TMC SPECIFICATION NO. S-272

TITLE: MODIFICATIONS FOR CANADIAN RCR SYSTEM JOB

PAGE	UNIT	DRAWING NUMBER	LOCATION	CANADIAN NAMEPLATE NO.
2	RSA-2	MS-385	FR. PANEL	NP-10006
3	RSC-2	A-878	REAR OF CHASSIS	"
4	RSD-2	MS-377	FR. PANEL	"
5	RSF-2	A-506	REAR OF CHASSIS	"
6	RSM-2	MS-402	FR. PANEL	"
7	RSP-2	A-478	REAR OF CHASSIS	"
8	FFR-2	A-139	"	"
9	FFRD	A-318	"	"

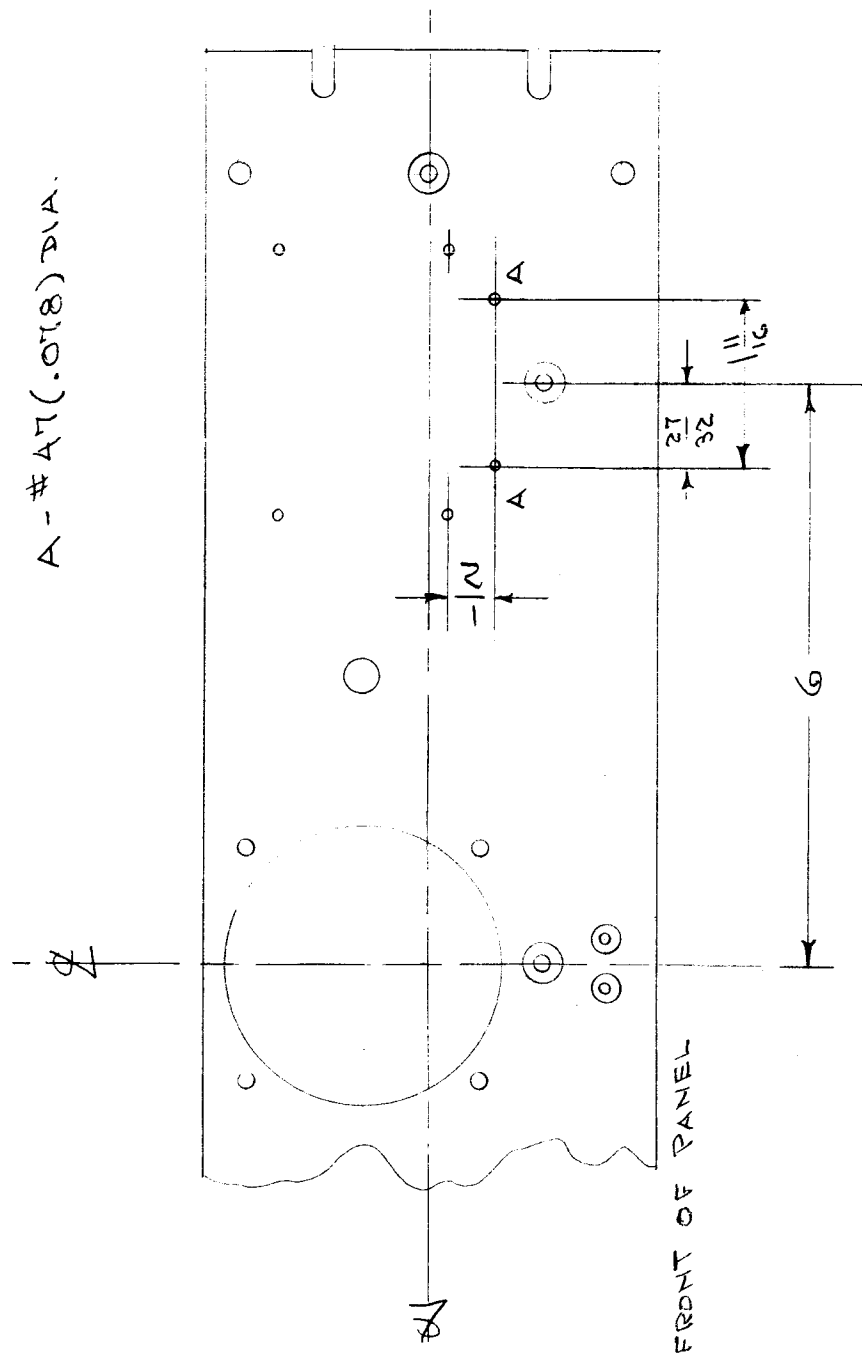
MODIFY MS-385, FRONT PANEL OF RSA-2 AS ABOVE. (ADD 2 "A" HOLES.)

A - #47 (.018) DIA.

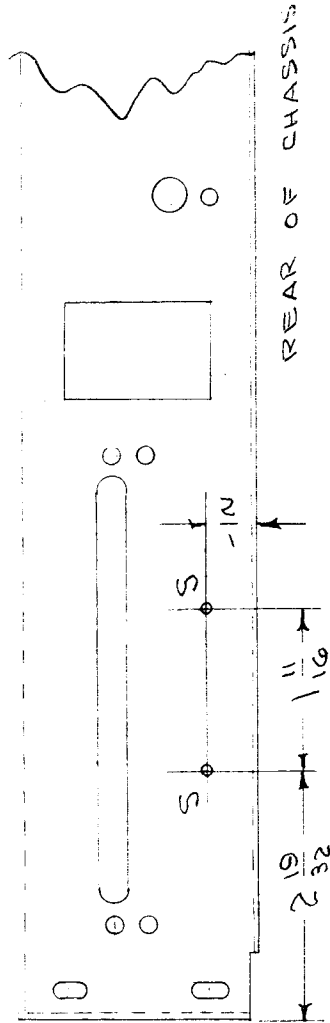
MODIFY A-878, CHASSIS ASSY. OF RSC-2
AS ABOVE. (ADD 2 "S" HOLES)

S-# A8(.076) DIA.

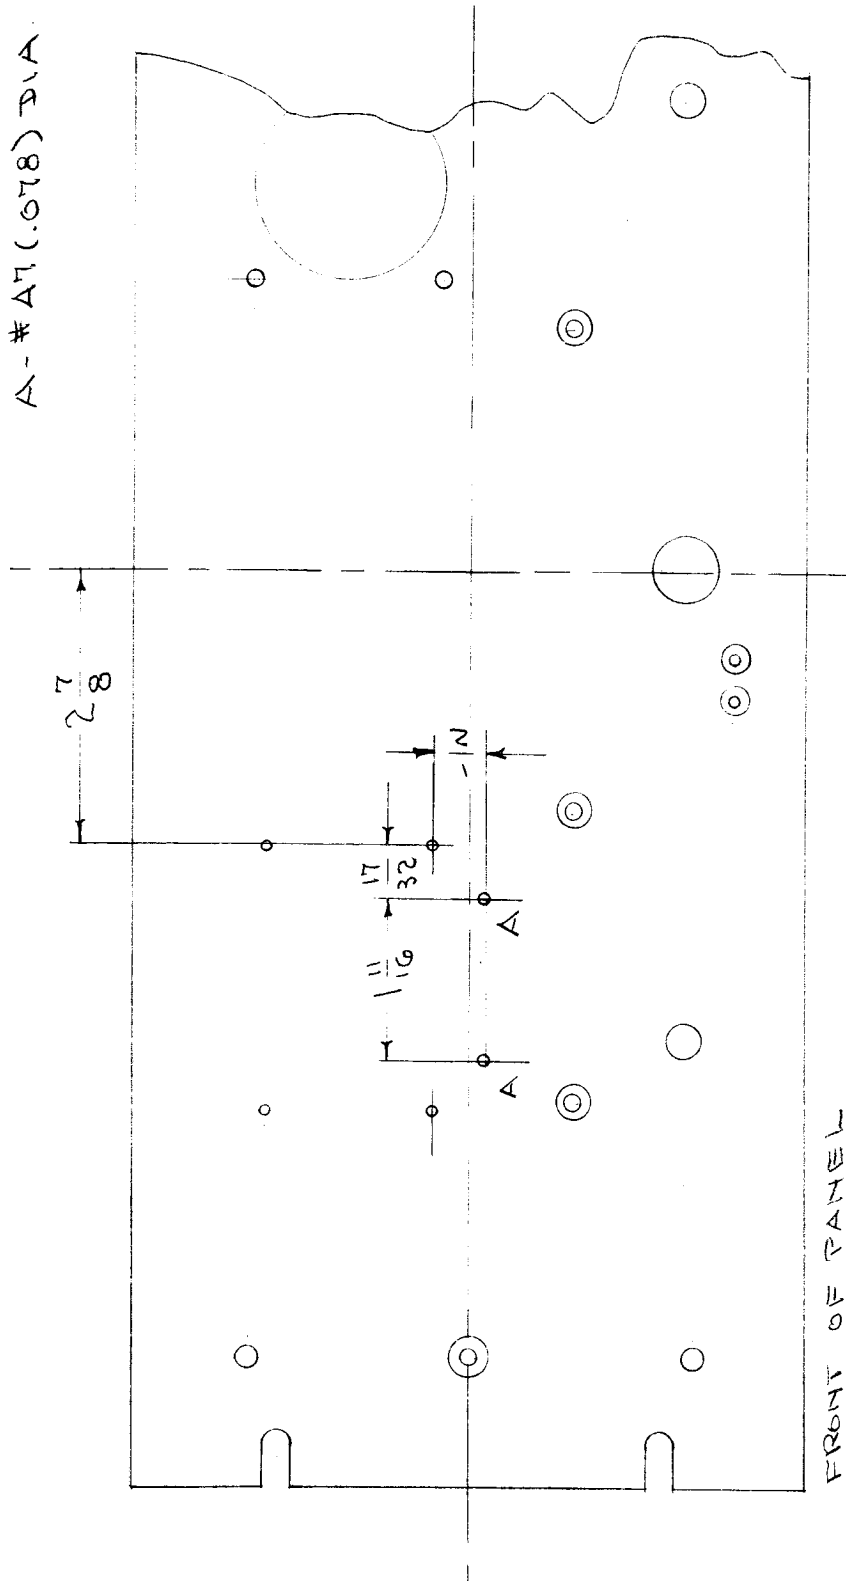
MODIFY MS-377, FRONT PANEL OF RSD-2 AS SHOWN ABOVE. (ADD 2 "A" HOLES).

A - # A7 (.078) DIA

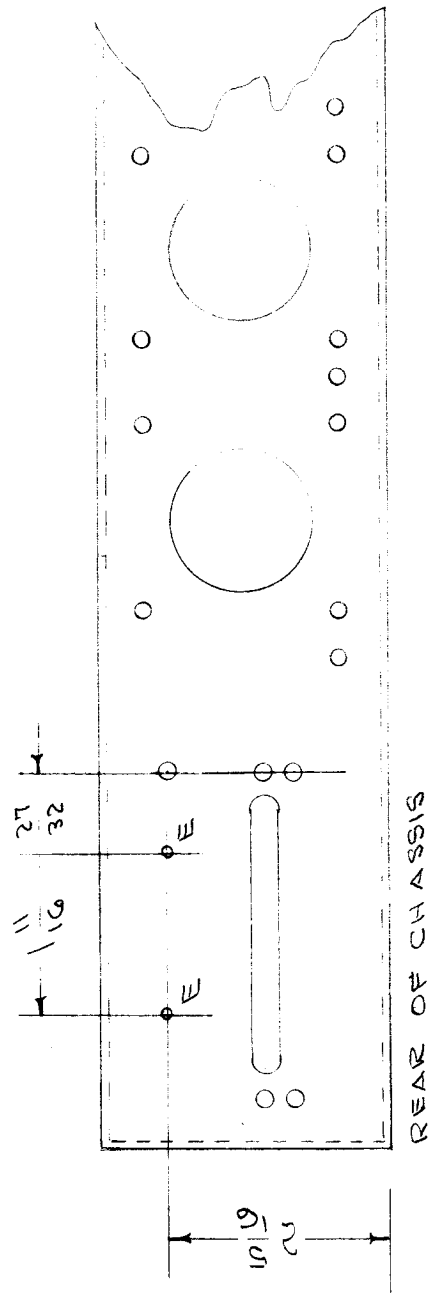
MODIFY A-506, CHASSIS ASSY. OF RSE-2
AS ABOVE. (ADD 2 "E" HOLES)

E - #48 (.016) DIA.

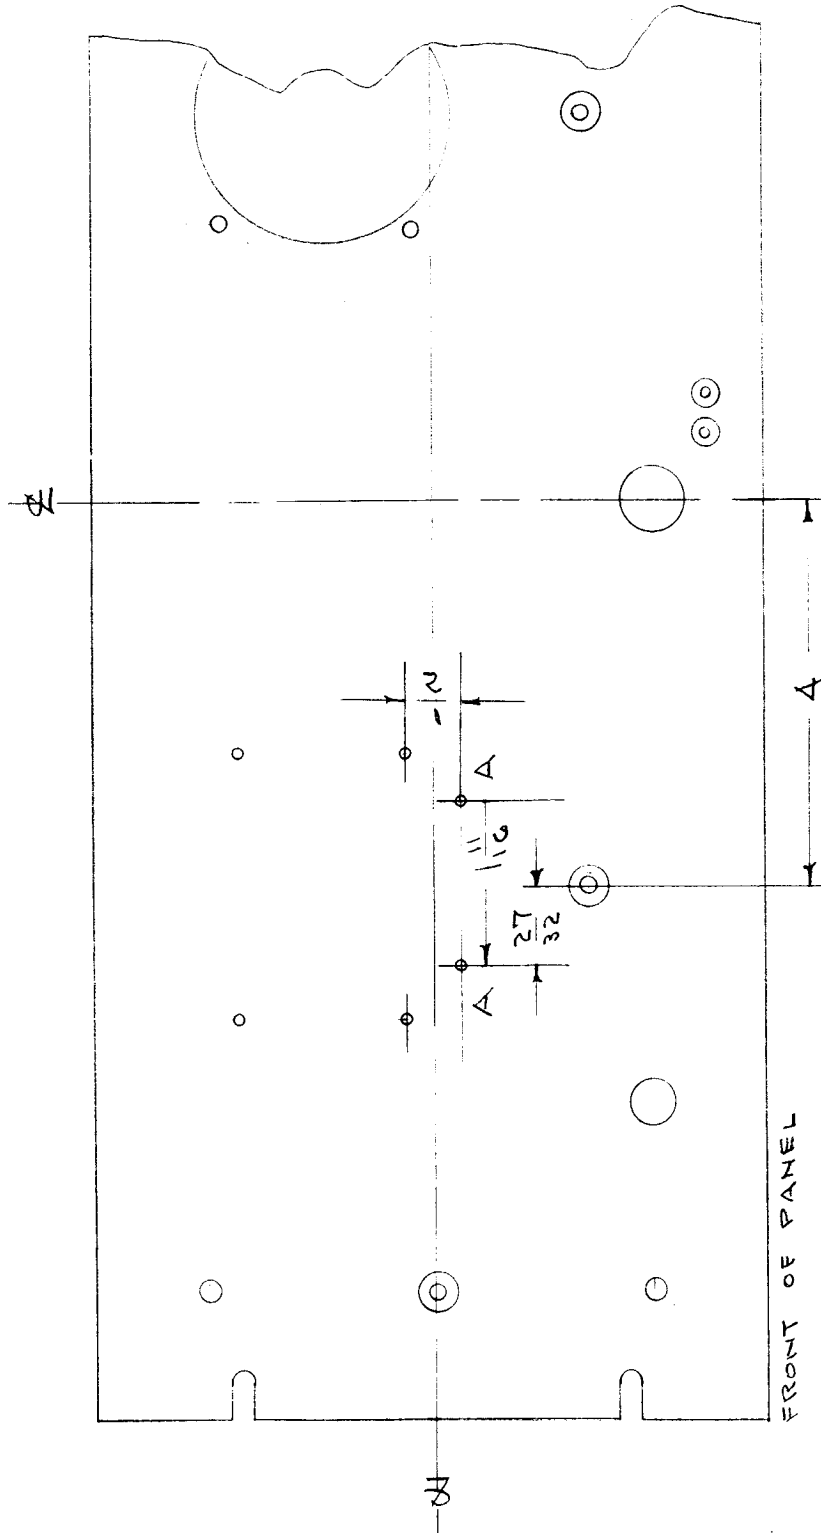
MODIFY MS-402, FRONT PANEL OF RSM-2 AS ABOVE. (ADD 2 "A" HOLES)

A - # AT (.048) DIA.

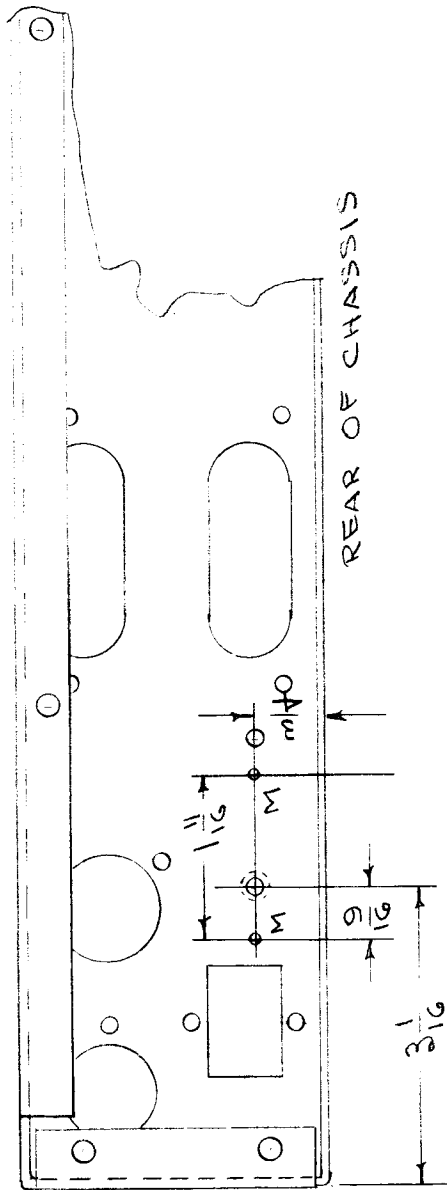
MODIFY A-478, CHASSIS ASSY. OF RSP-2
AS ABOVE. (ADD 2 "M" HOLES)

M- #48(.076) DIA

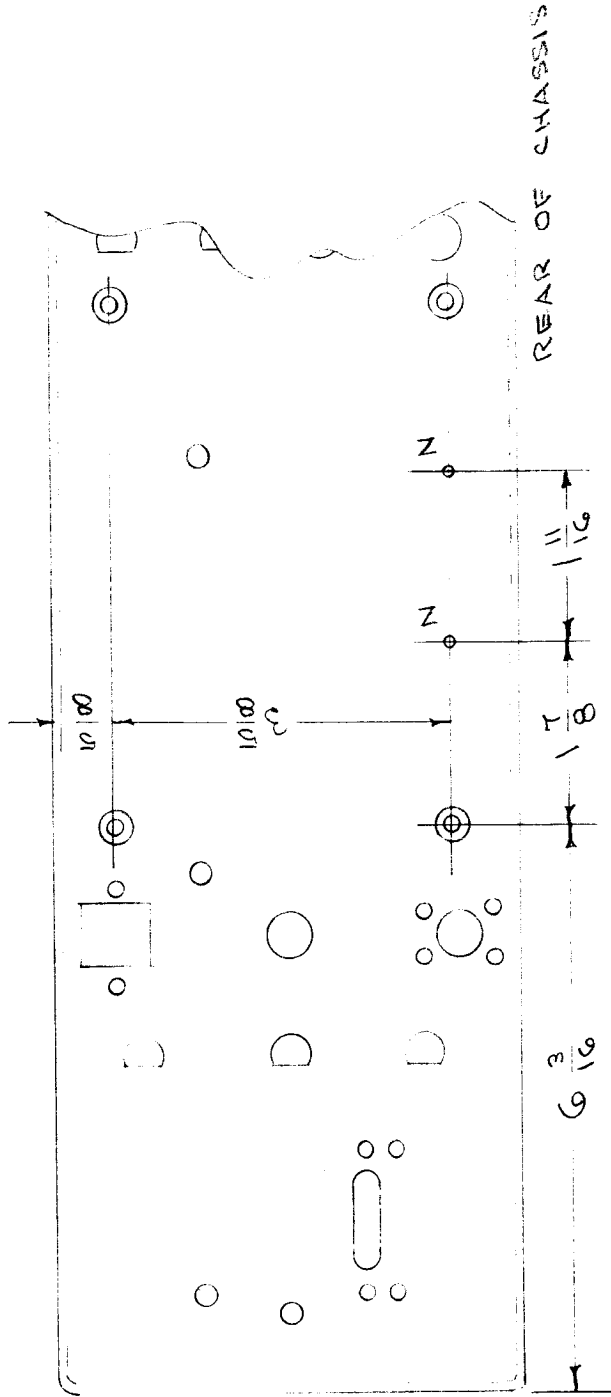
*MODIFY A-139, CHASSIS FRAME ASSY. OF FER-2
AS ABOVE. (ADD 2 "N" HOLES)*

N - #48 (.076) DIA.

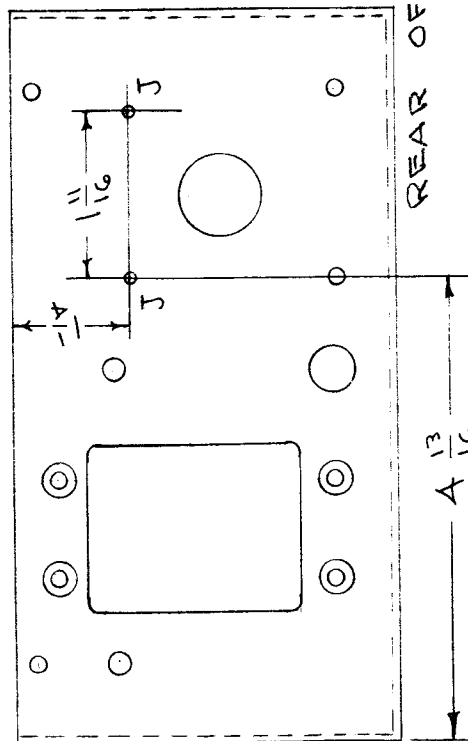
MODIFY A-318, HEAD FRAME ASSY. OF FFD-
AS ABOVE. (ADD 2 "J" HOLES.

K-#48 (.076) DIA.
